2019
OXFORD ELEMENTARY SCHOOL
UNIFIED SCHOOL DISTRICT 358
 319 East College Street, Oxford, Kansas 67119

DRAWINGS ISSUED		
NO.	DATE	ITEM ISSUED
4	4/9/19	ADDENDUM 5
6	4/2/19	ADDENDUM 3
1	8/1/18	ISSUED FOR BIDS
6	8/1/18	10% REVIEW
5	7/5/18	REVIEW
4	6/24/18	REVIEW
3	5/6/18	REVIEW
2	4/27/18	REVIEW
1	4/08/18	REVIEW

M1.1

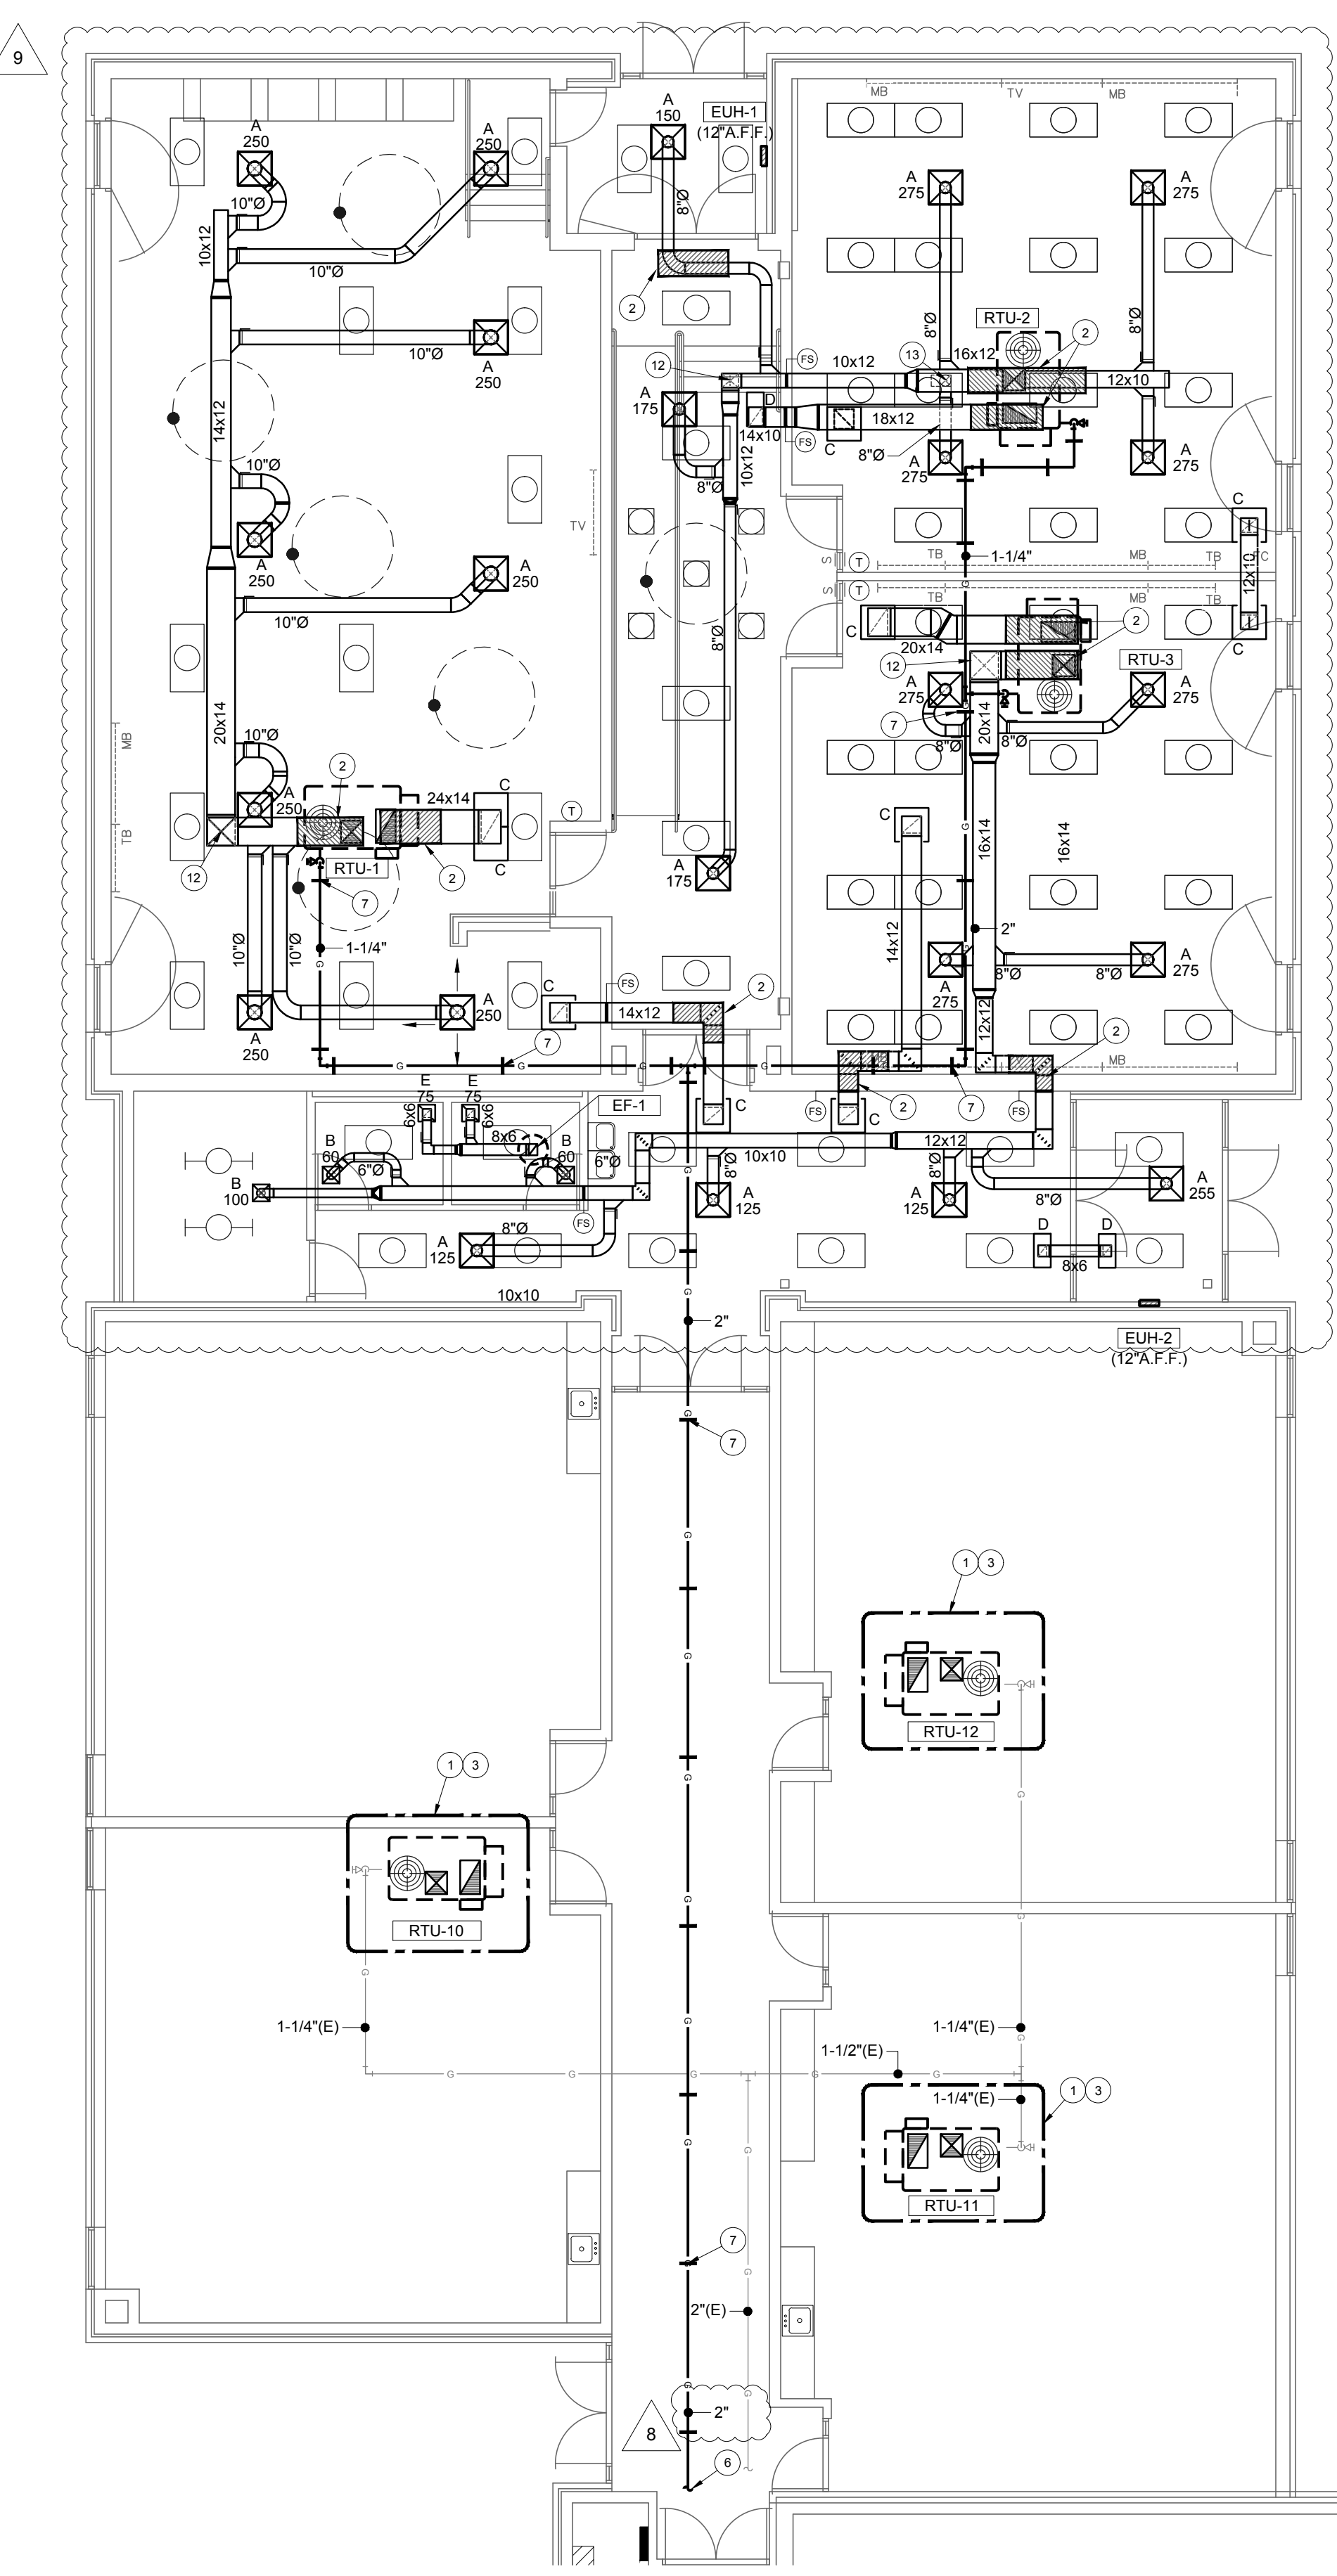
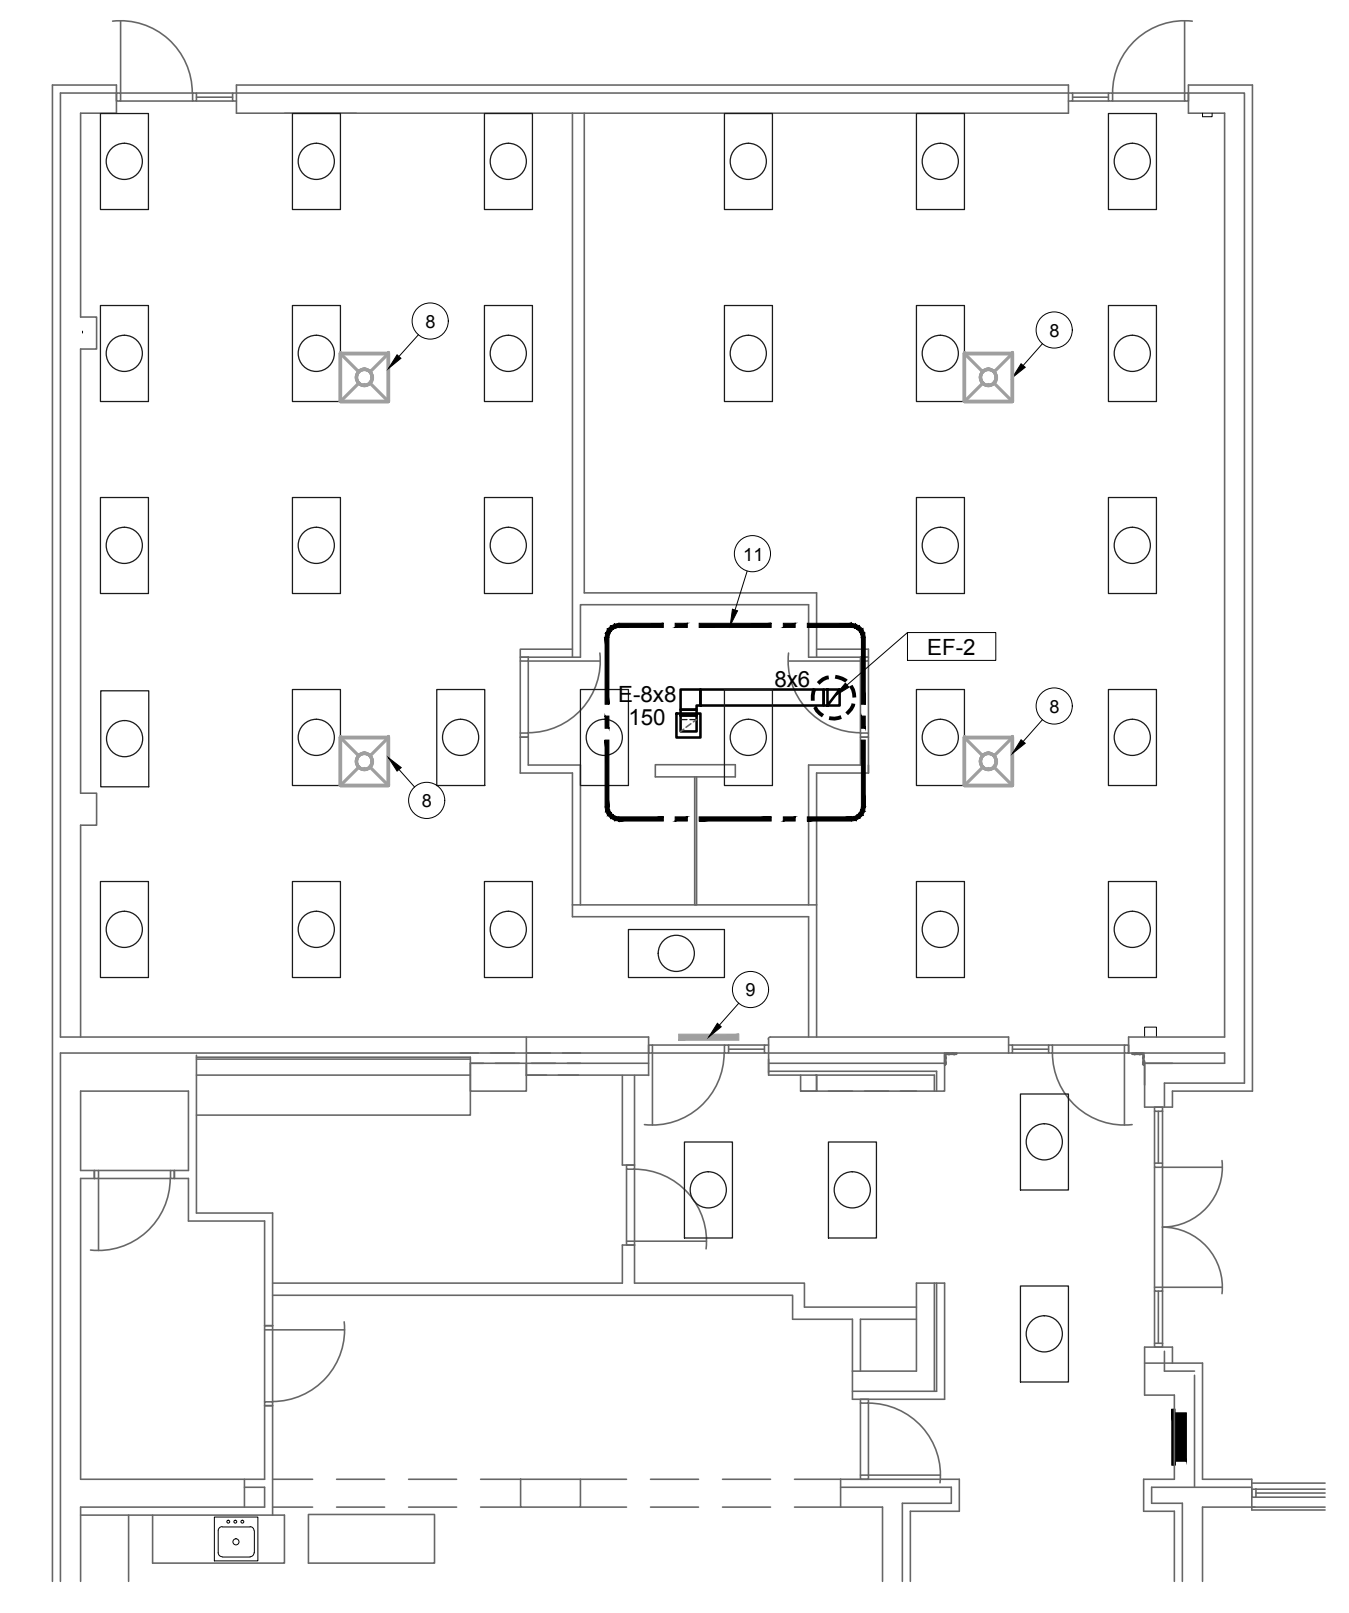
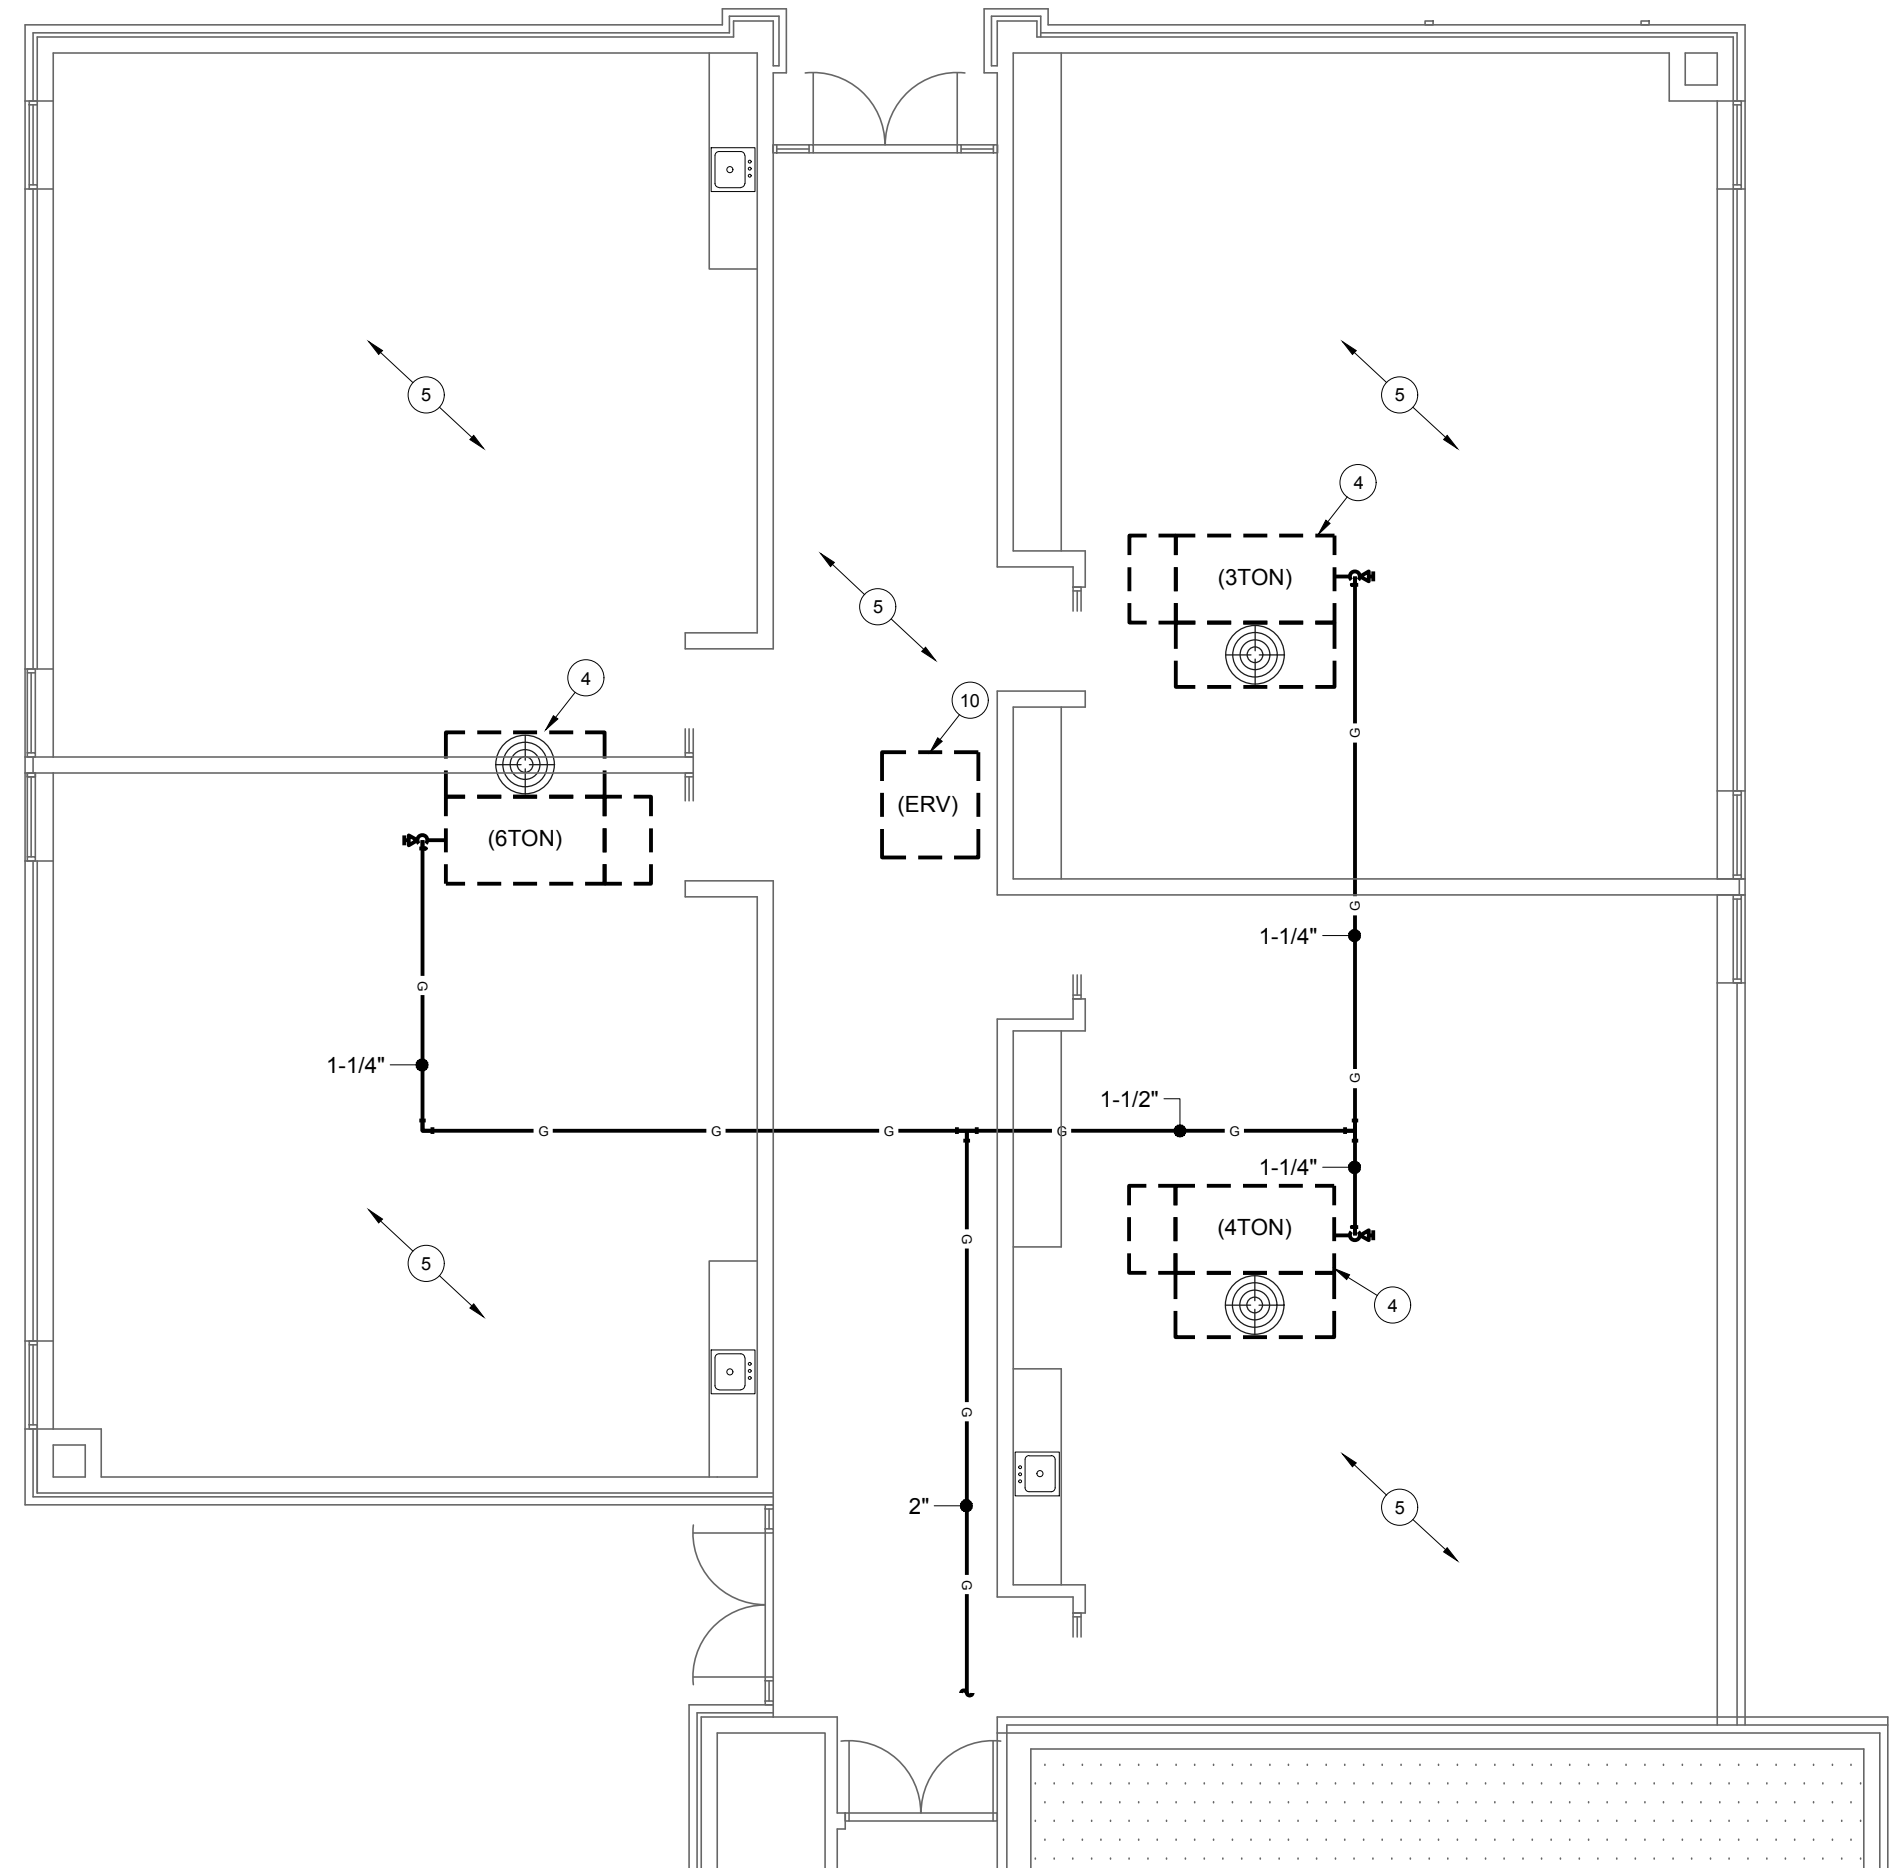
- REPLACE RTU AS PART OF ALTERNATE #7. REFER TO RTU SCHEDULE FOR NEW EQUIPMENT INFORMATION.
- PROVIDE STRUCTURAL STEEL DUCT SHROUD TO PROTECT DUCT PENETRATION INTO SHELTER. REFER TO DETAIL ON STRUCTURAL SHEETS FOR ADDITIONAL INFORMATION.

- PROVIDE TRANSITION ROOF CURB FOR INSTALLATION OF NEW ROOF TOP UNIT. CONNECT EXISTING GAS PIPING TO NEW UNIT AND CONNECT PER MANUFACTURERS RECOMMENDATIONS.

- REMOVE EXISTING ROOF TOP UNIT AS PART OF ALTERNATE #7.
- ALL EXISTING DUCTWORK, S.A. / R.A. GRILLES TO REMAIN IF ALTERNATE #7 IS ACCEPTED.
- EXTEND GAS PIPING BACK TO EXISTING 4" GAS PIPING AND CONNECT. CONTRACTOR TO COORDINATE WITH LOCAL UTILITY TO DETERMINE IF EXISTING GAS METER & SERVICE LINE HAS CAPACITY FOR NEW ADDITIONAL LOAD = (390 MBH). PROVIDE NEW METER, REGULATOR, ETC. AS REQUIRED.

- GAS PIPING LOCATED ON ROOF. PROVIDE MIRO SUPPORT FOR ALL GAS PIPING. INSTALL EVERY 10'-0" AND AT EVERY FITTING. ALL GAS PIPING ON ROOF TO BE PAINTED. (TYP.)

- ALL DIFFUSERS LOCATED IN SPACE TO BE REUSED IN NEW WORK. COORDINATE EXACT LOCATION OF REUSED DIFFUSERS WITH NEW CEILING, LIGHTING, ETC.
- EXISTING RETURN AIR GRILLE TO REMAIN. FIELD VERIFY WITH NEW CEILING.

- REMOVE EXISTING ERV UNIT AND ALL ASSOCIATED CONTROLS. CAP ROOF CURB WEATHER TIGHT AS PART OF ALTERNATE #7.
- PROVIDE EXHAUST FAN AS PART OF ALTERNATE #6. REFER TO EXHAUST FAN SCHEDULE FOR NEW EQUIPMENT INFORMATION.

- DROP DUCTWORK AND ROUTE BELOW JOISTS.
- PROVIDE BRANCH CONNECTION ON BOTTOM OF DUCT.
